New Albany Architectural Review Board
Monday, April 14, 2025 Meeting Minutes - Approved

ARB-80-2024 Certificate of Appropriateness

ARB-15-2025 Certificate of Appropriateness

**THE AVALON SENIOR LIVING WALL SIGNS
CERTIFICATE OF APPROPRIATENESS**

Dimensions for Wall Sign A

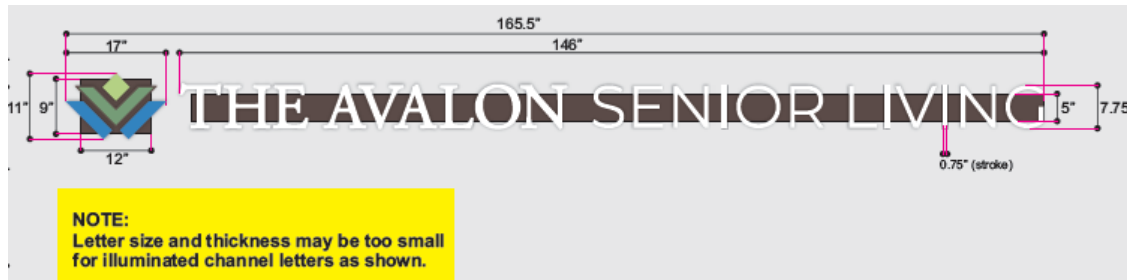
- a. Area: 12.64 square feet per side [meets code].
 - b. Location: the sign is proposed to be installed on the street front on Miller Avenue at the intersection of East Main Street to replace the existing sign [meets code].

- c. Lighting: Internal, LED - 120 Volt, 50 Watt per set [meets code].
 - d. Width: 13.79 feet [meets code].
 - e. Height: 11 inches [meets code].
 - f. Lettering Height: 7.75 inches [meets code].

- g. Colors: white, blue, and green [meets code].
 - h. Mount: Raceway [meets code].
- The sign reads “The Avalon Senior Living” in white lettering, white trim cap, white returns, and a white acrylic face. The raceways are painted to match the color of the brick.

- The sign is proposed to be acrylic and aluminum with a metal raceway, which are permitted sign materials.
 - C.O. 1169.12(a)(1) states that signs are to be consistent with the design/style of the building on which they are located. The proposed materials appear to be the same used on the other elevation signs.

Dimensions for Wall Sign B

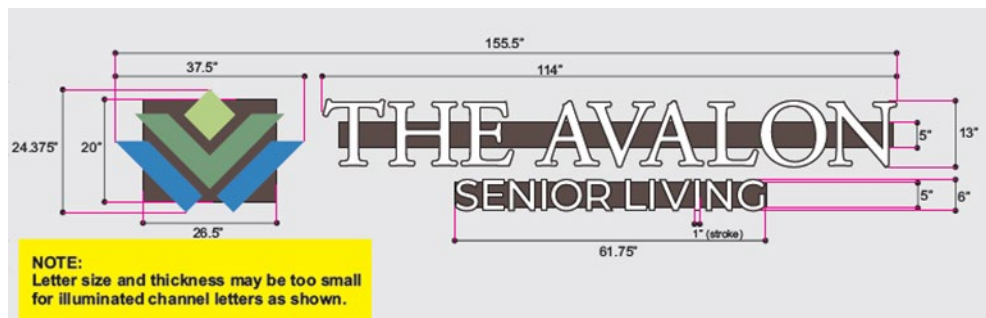
- a. Area: 26 square feet per side [meets code].
 - b. Location: the sign is proposed to be installed on the street front on South High Street to replace the existing sign [meets code].

- c. Lighting: Internal, LED - 120 Volt, 50 Watt per set [meets code].
 - d. Width: 13 feet [meets code].
 - e. Height: 2 feet [meets code].
 - f. Lettering Height: 13 inches for The Avalon and 6 inches for Senior Living; 19 inches total [meets code].

- g. Colors: white, blue, two shades of green [meets code].
 - h. Mount: Raceway [meets code].
- The sign reads "The Avalon Senior Living" in white lettering, white trim cap, white returns, and a white acrylic face. The raceways are painted to match the color of the brick.

- The sign is proposed to be acrylic and aluminum with a metal raceway, which are permitted sign materials.
 - C.O. 1169.12(a)(1) states that signs are to be consistent with the design/style of the building on which they are located. The proposed materials appear to be the same used on the other elevation signs.
